AMENDMENTS TO THE DRAWINGS

The attached sheets of drawings include the following changes:

FIG. 1 (PRIOR ART)

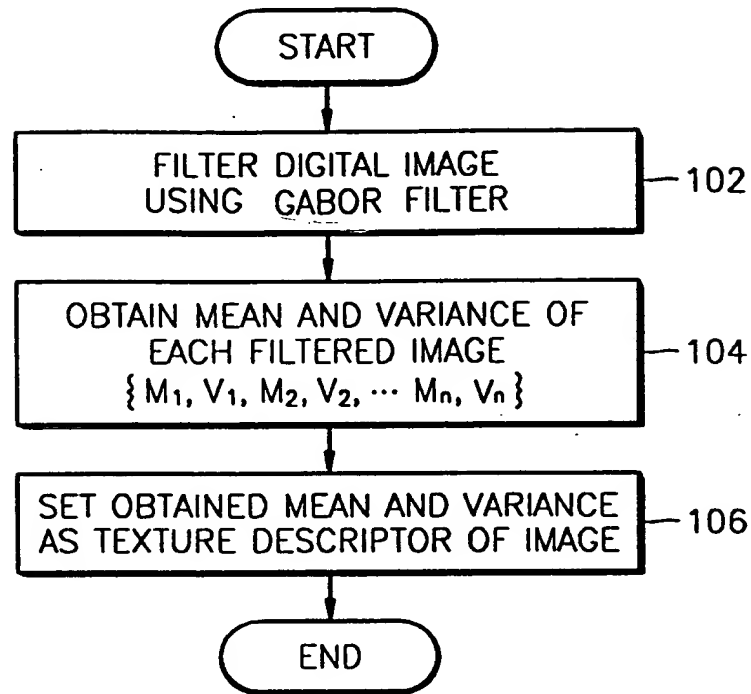
As requested by the Examiner, Figures 1, 3, and 5-7 have been amended to change the term, "GARBOR" to "GABOR".
